A Proposal for Updating Annex 93A.1 Channel Operating Margin (COM) with a FFE Reference Receiver for IEEE P802.3dj

Mike Li, Hsinho Wu, Masashi Shimanouchi, Itamar Levin, Ariel Cohen, Ilia Radashkevich

Intel

Nov, 2023

- Modify Figure 93A-1

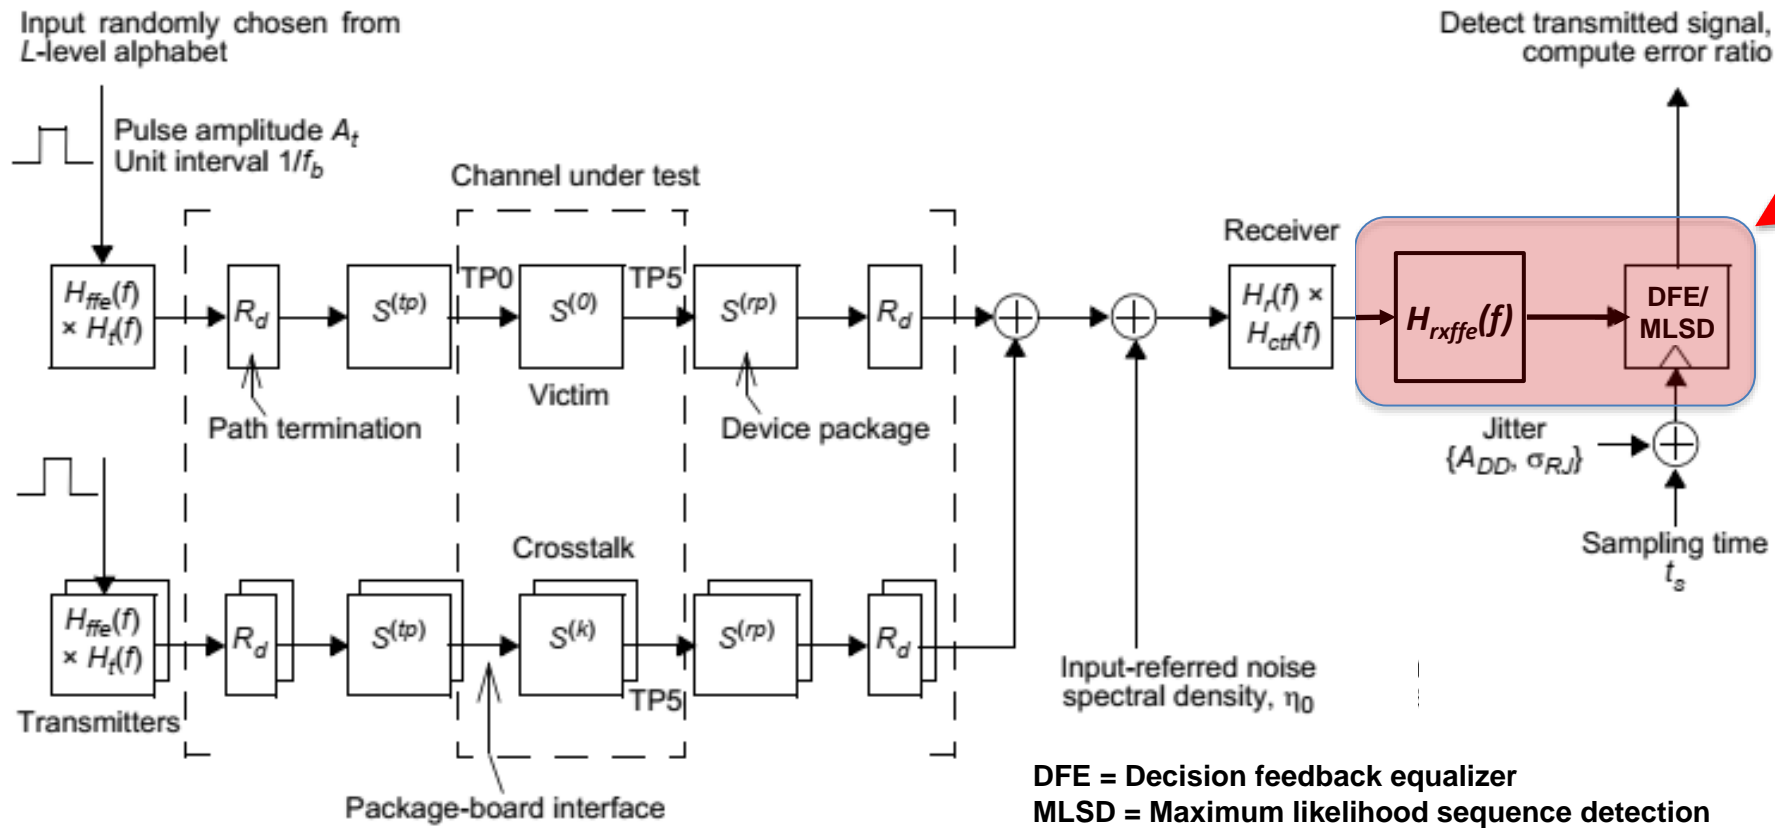
- a) Modify Figure 93A-1
- b) Modify Table 93A-1

i. a) Update 93A.1 Channel Operating Margin
